Department for Transport,  
Great Minster House  
33 Horseferry Road  
London SW1P 4DR

Ref: Invitation to comment TR020001-003654

**Planning Act 2008 and the Infrastructure Planning (Examination Procedure) Rules 2010:  
Application by London Luton Airport Limited (“the Applicant”) Seeking Development Consent for  
the Proposed London Luton Airport Expansion (“the Proposed Development”).**

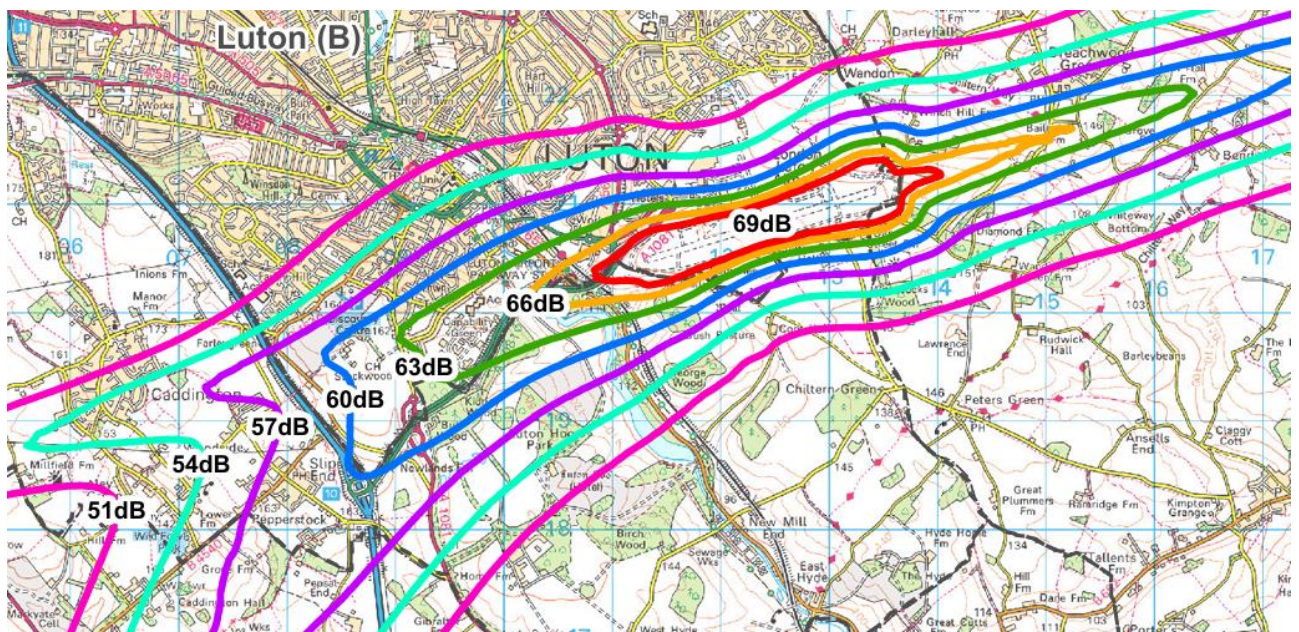
For example, the northern half of Caddington (at the left side of the extract below) which is effectively overflowed by easterly arrivals track, is ineligible and the southern half is only eligible for £4,000 under AN5. The same issue affects the large area of South Luton in the 54dB contour. This is because easterly arrivals only on average occur around 30% of the time - but course when they do, the noise is significant and detrimental to quality of life.

Likewise, the extensive Park Homes site in Slip End, which falls inside the 57dB contour and in the eyes of the Applicant would be eligible for £6,000 – has older mobile homes which require more extensive insulation work to achieve a worthwhile reduction of internal noise. The Applicant has chosen not to recognise this despite it being raised. See REP7-104 p10.
